RHODE ISLAND CONTRACT NO.2016-CB-059

0009N WASHINGTON BRIDGE NORTH NO 700 (57A T-J)

NOTICE TO PROSPECTIVE BIDDERS

ADDENDUM NO. 2 Prospective bidders and all concerned are hereby notified of the following changes in the Plans, Specifications, Proposal and Distribution of Quantities for this contract. These changes shall be incorporated in the Plans, Specifications, Proposal and Distribution of Quantities, and shall become an integral part of the Contract Documents.

PARAPET DEMOLITION
AND REPLACEMENT
DETAILS

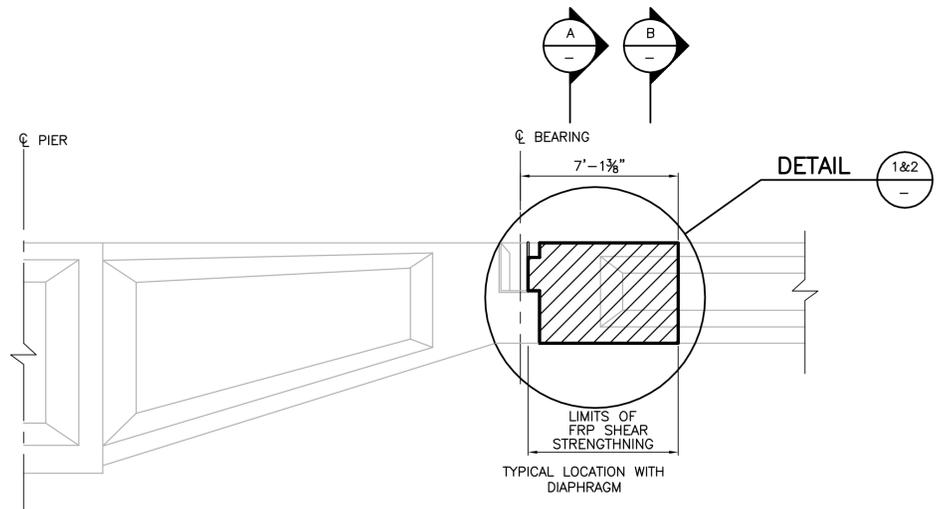
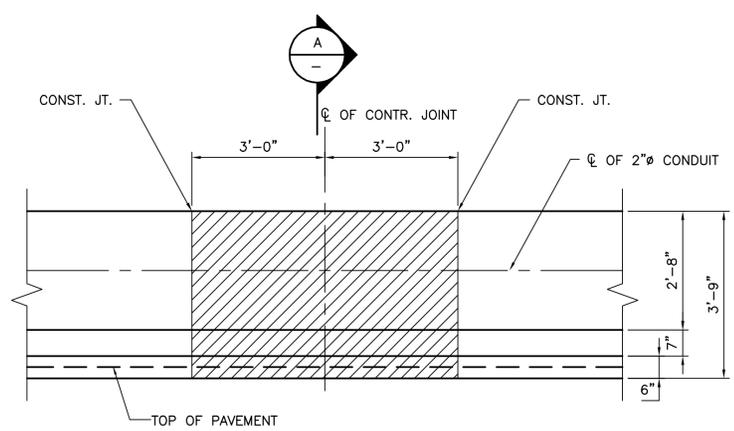
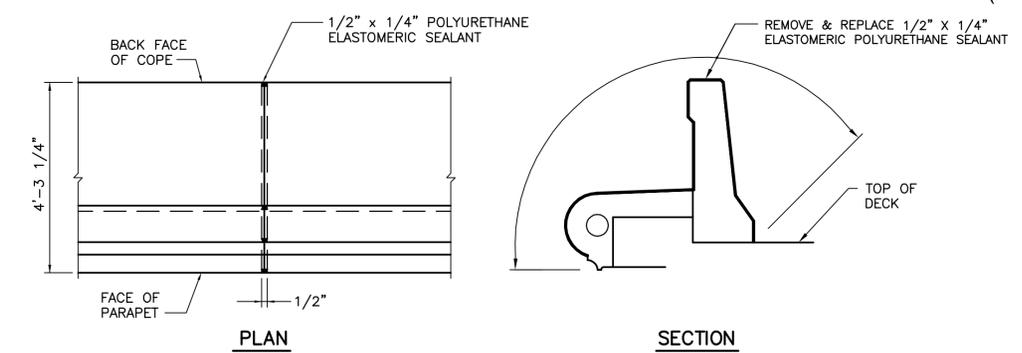
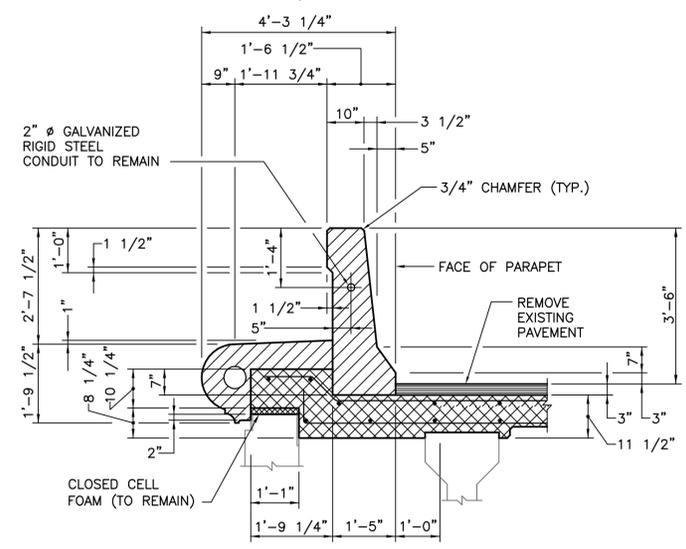
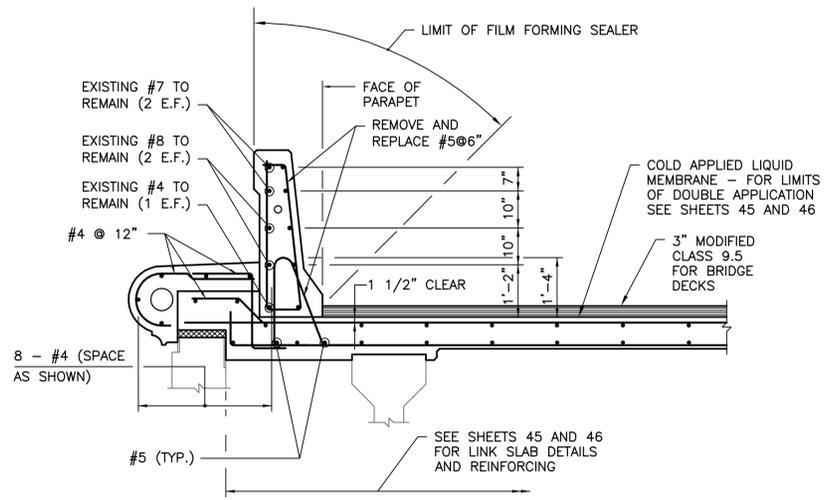
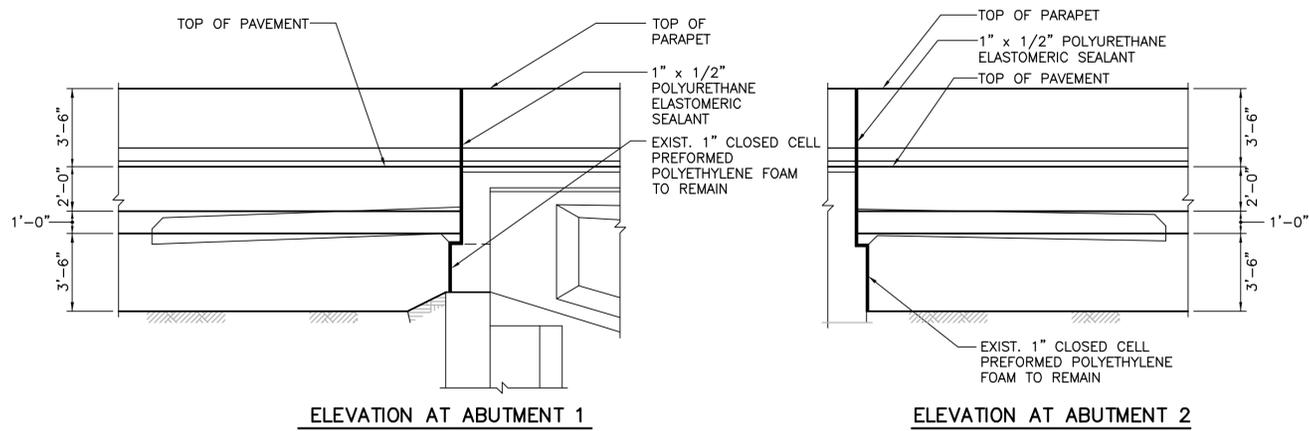
3.1 Sheet 24 - Parapet Demolition and Replacement Details - Added note 5 under Parapet Demolition and Replacement notes.

DROP-IN-BEAM REPAIR & STRENGTHENING DETAILS

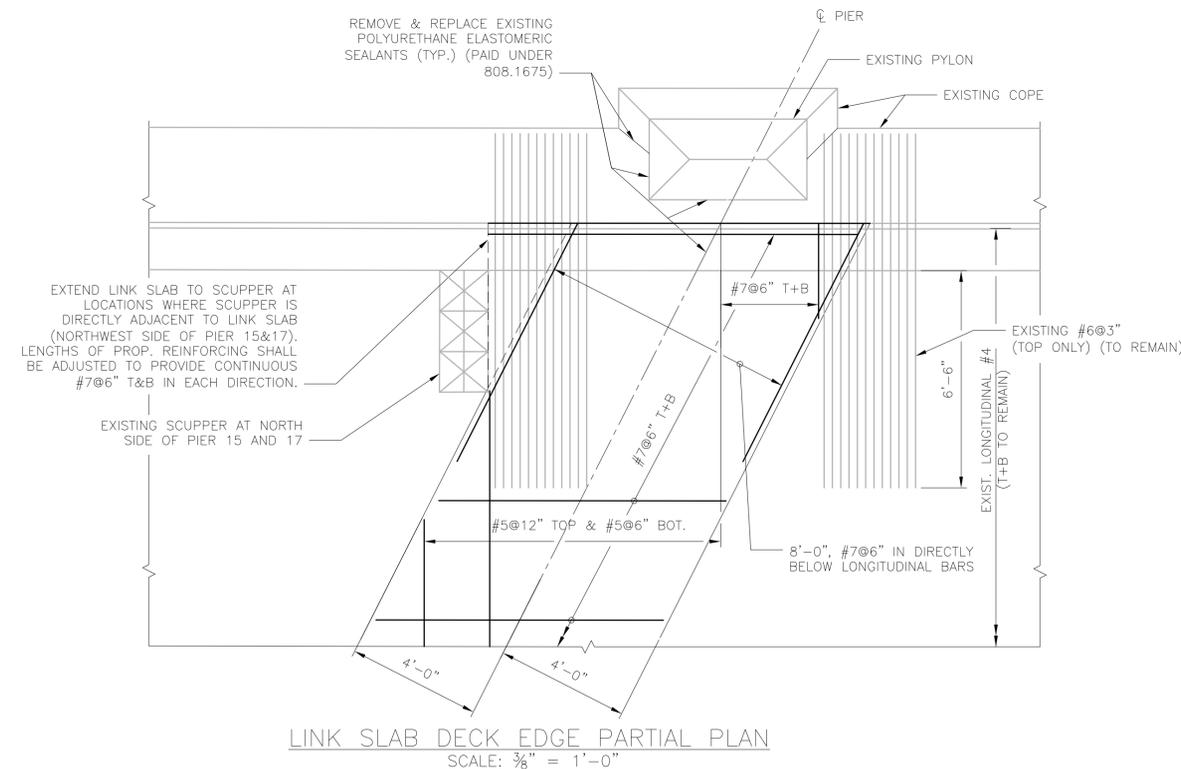
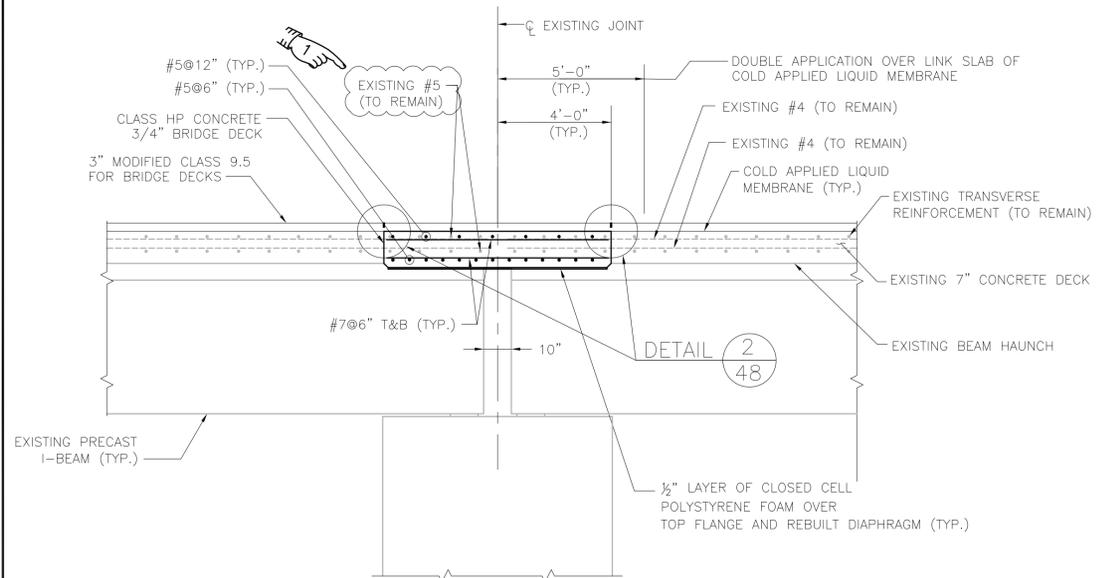
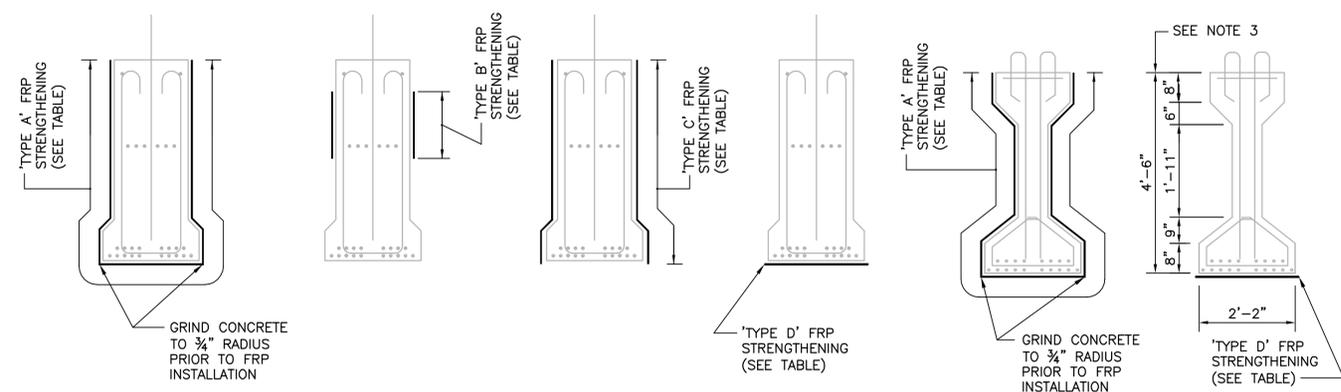
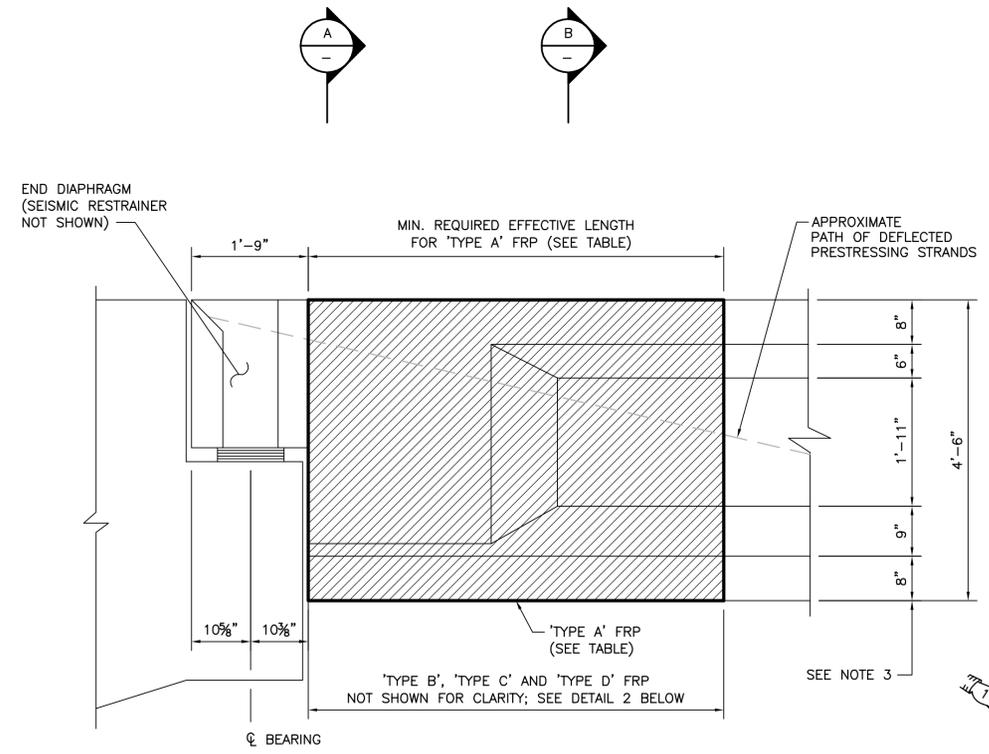
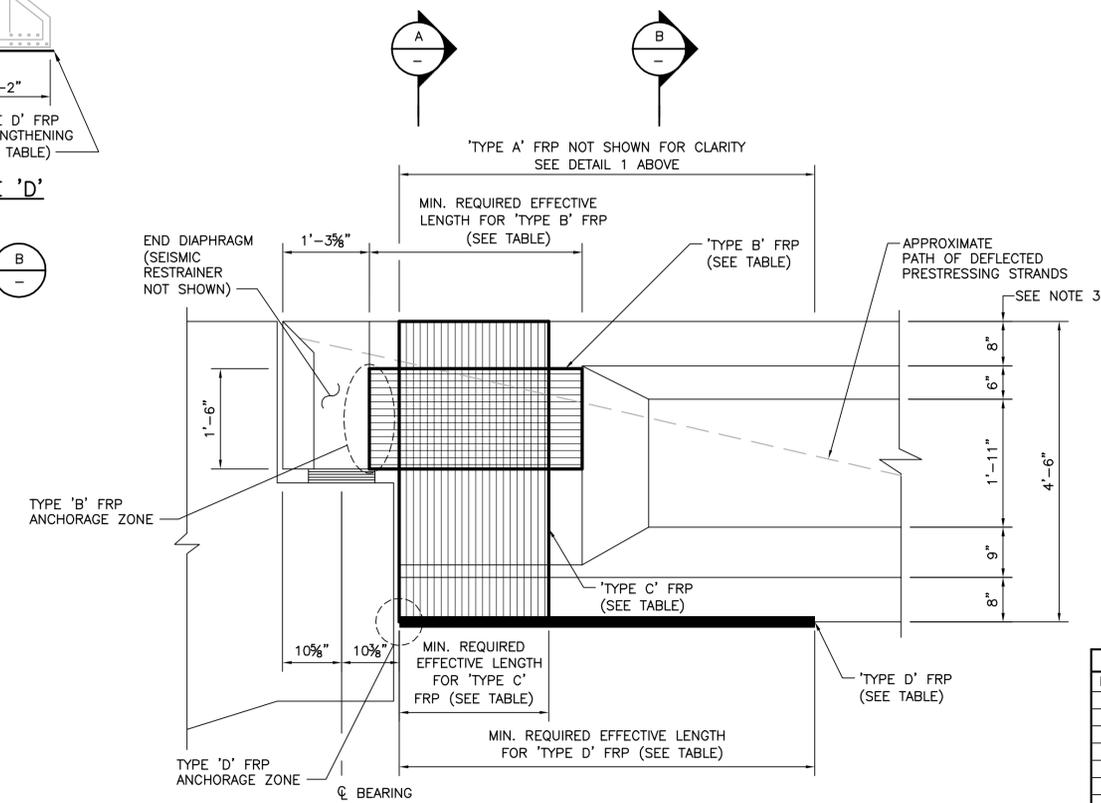
3.3 Sheet 43 - Drop-In-Beam Repair & Strengthening Details - Revised note 8 reference to 820.9901.

| REVISIONS | | | RHODE ISLAND DEPARTMENT OF TRANSPORTATION | |
|-----------|----------|----|---|--|
| | | | LINK SLAB DETAILS-2 | |

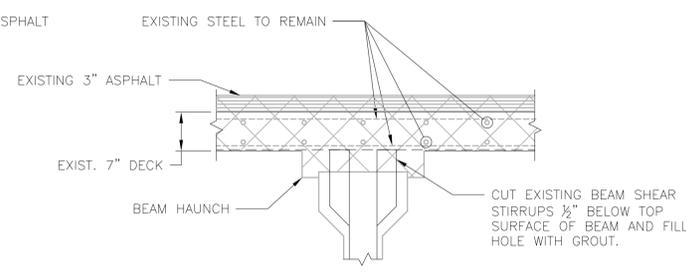
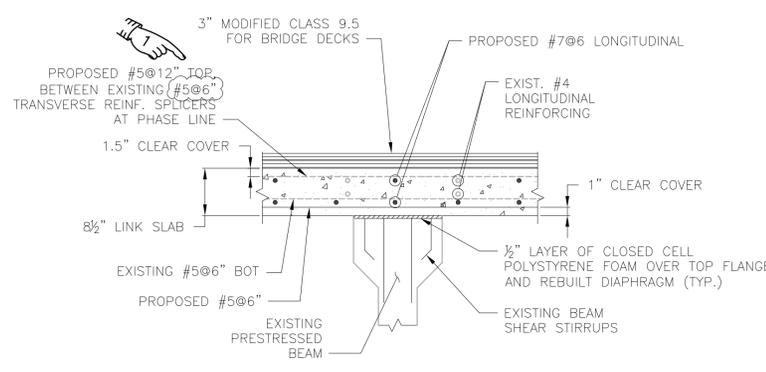
3.4 Sheet 46 - Link Slab Details 2 - Notes 2 & 7 have been modified, Proposed Link Slab at Piers 15-17 has been modified, Existing Transverse Section Through Diaphragm and Proposed Section Through Diaphragm have been modified.

DECK JOINT DETAILS SHEET 3

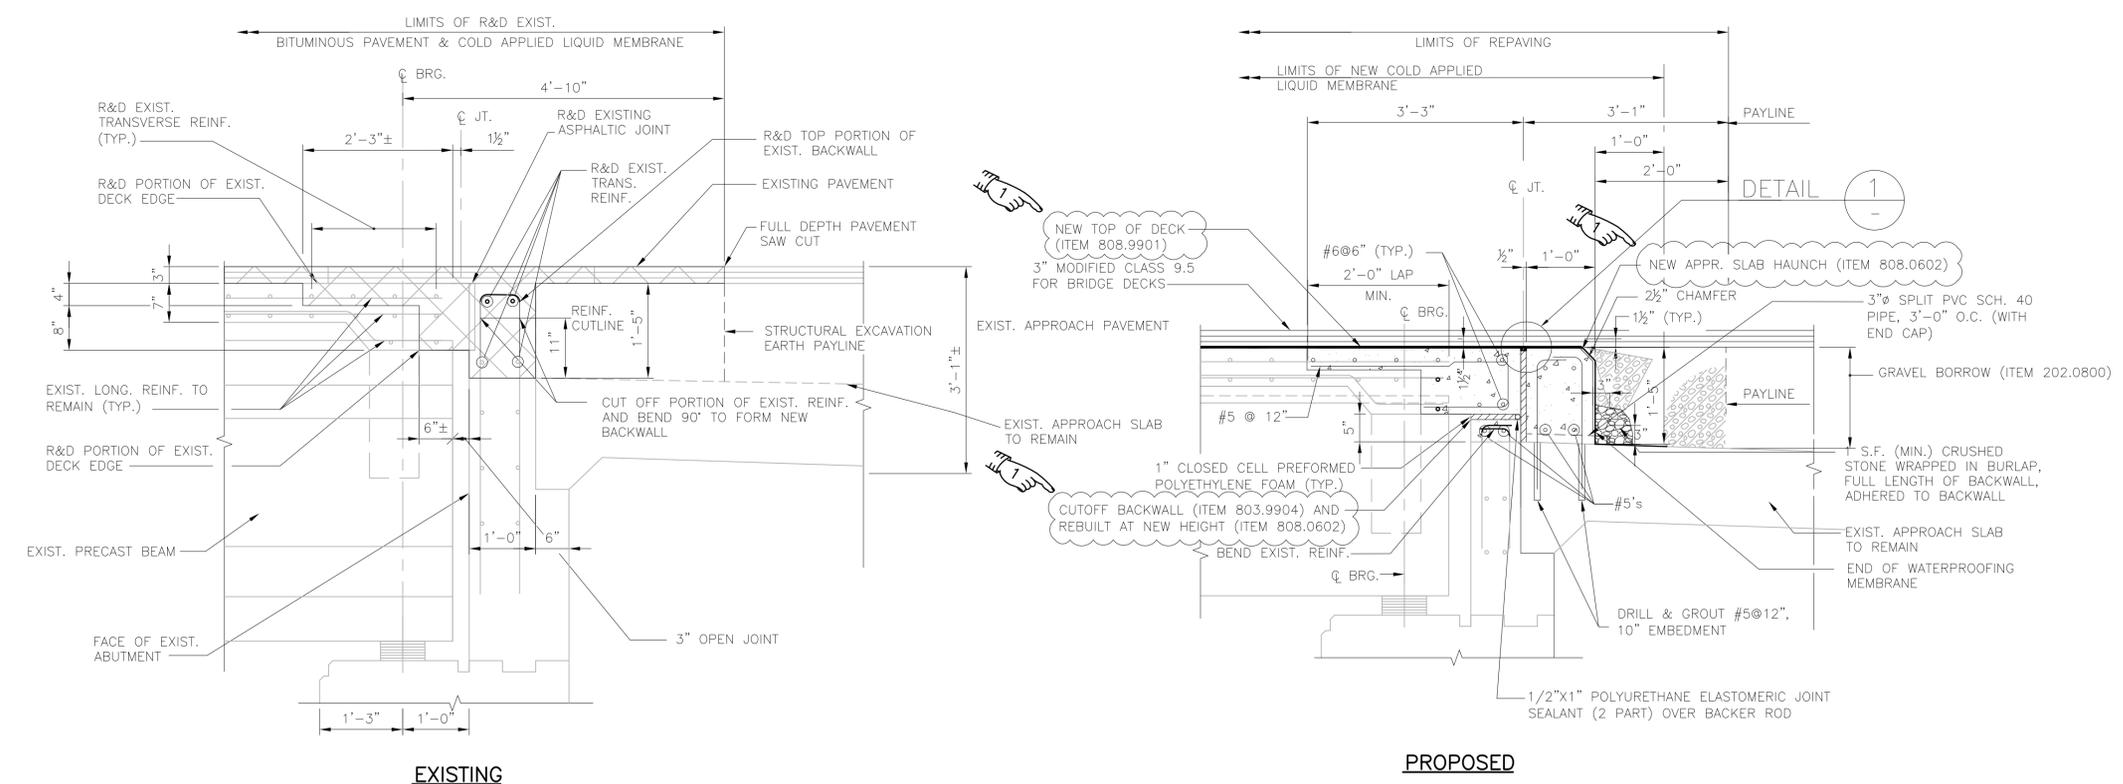
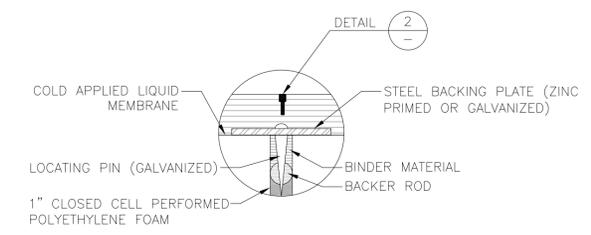
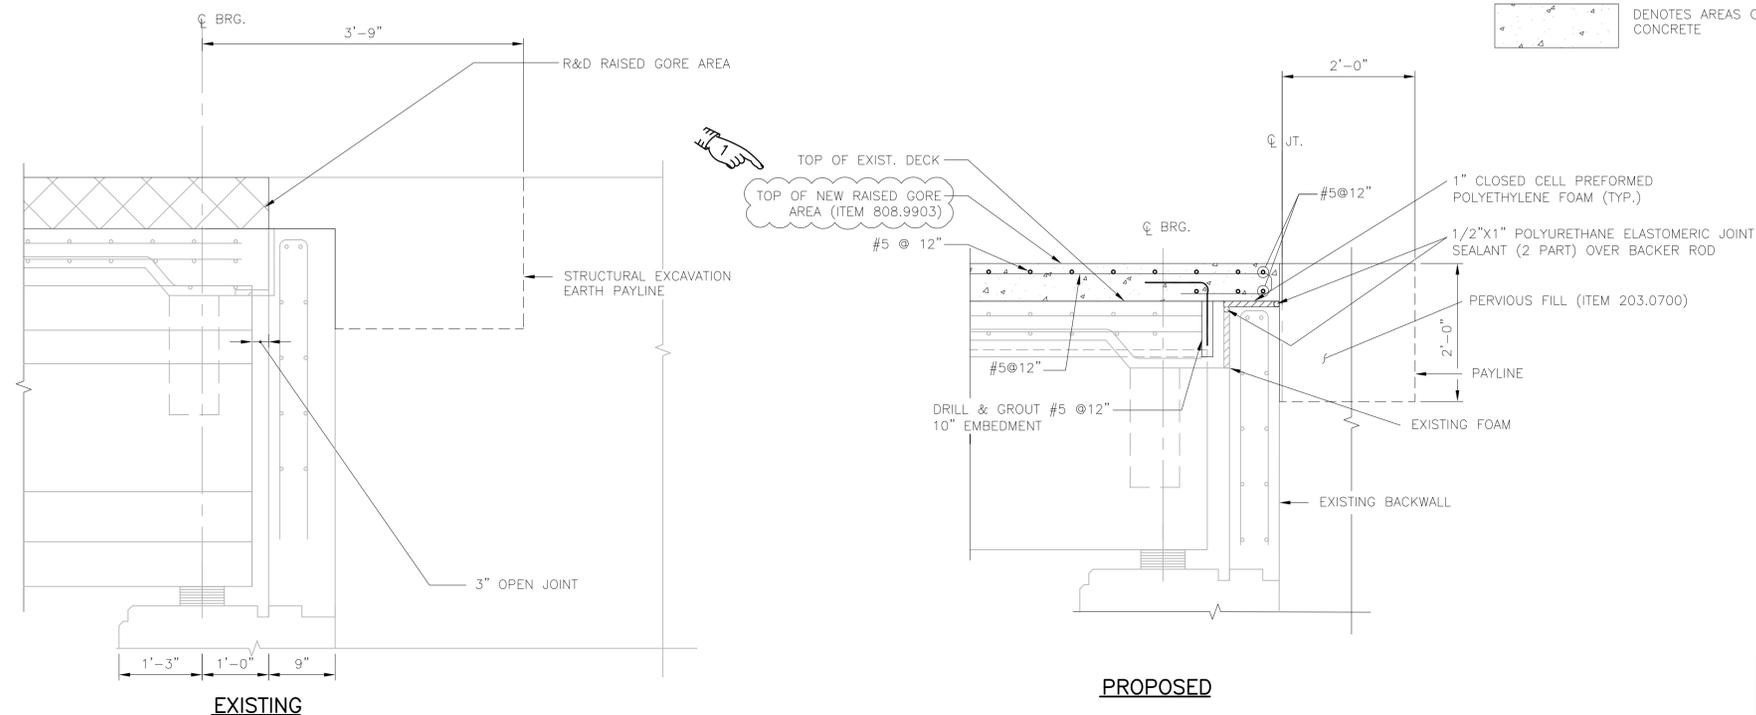
3.5 Sheet 49 - Deck Joint Details Sheet 3 - Notes 2 & 9 have been modified. Proposed Section at Abutment 2 and Proposed Section at Abutment 2 Gore Area have been modified.
